Access Compliance Report

Public Rights-of-Way

(Curb Ramps)

Intersection ID: N/A	Main Street: NEW_FASHION_WY	Cross Street: N/A	Location: SW
ADA ID: 343DFC5033FA	Ramp Type: Perp	Initial Pass/Fail: Fail	Overall Compliance: No
Severity Score: 33.75			
Codes/Mitigation Info/Possible Solution		Field Measurements/Component Compliance

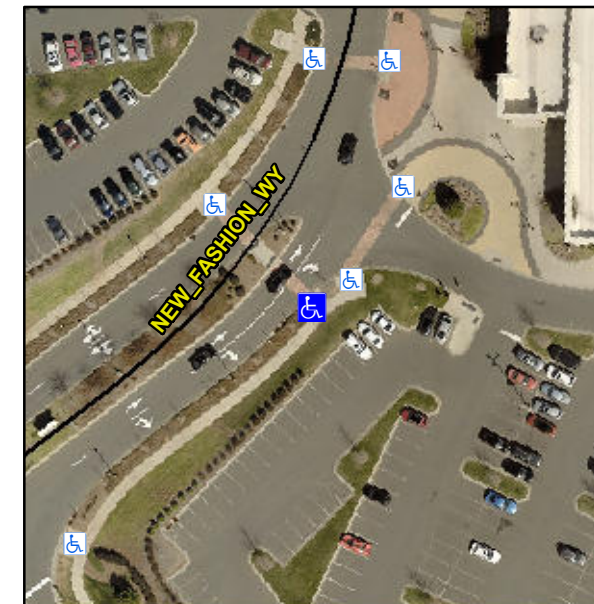
R304.5.1, R304.5.3

Compliance	Description	Data	Compliance	Description	Data
N/A	Ramp Length (in)	87.0	Yes	Ramp Slope (%)	5.2
No	Ramp Width (in)	47.5	No	Ramp XSlope (%)	9.3
N/A	Flare Type LT	N/A	N/A	Flare Type RT	N/A
N/A	Flare Slope LT (%)	N/A	N/A	Flare Slope RT (%)	N/A
N/A	Flare Traversable LT?	N/A	N/A	Flare Traversable RT?	N/A
N/A	Landing Length (in)	N/A	N/A	DWS Provided?	N/A
N/A	Landing Width (in)	N/A	N/A	DWS Contrast?	N/A
N/A	Landing Slope (%)	N/A	N/A	DWS Length (in)	N/A
N/A	Landing X Slope (%)	N/A	N/A	DWS Full Width?	N/A
N/A	Landing Curb? (Y/N)	N/A	N/A	DWS Offset (in)	N/A
N/A	Shared Landing?	N/A			
N/A	Gutter Ponding?	N/A	N/A	Gutter Slope (%)	N/A
N/A	Gutter Lip Ht (in)	N/A	N/A	Gutter X Slope (%)	N/A
N/A	Painted X Walk1?	Yes	N/A	Painted X Walk2?	N/A
	X Walk 1 Direction	To NW		X Walk 2 Direction	N/A
N/A	X Walk 1 Width (in)	80.0	N/A	X Walk 2 Width (in)	N/A
	X Walk 1 Slope (%)	4.8		X Walk 2 Slope (%)	N/A
	X Walk 1 X Slope (%)	9.2		X Walk 2 X Slope (%)	N/A

Remove & Replace Entire Ramp.
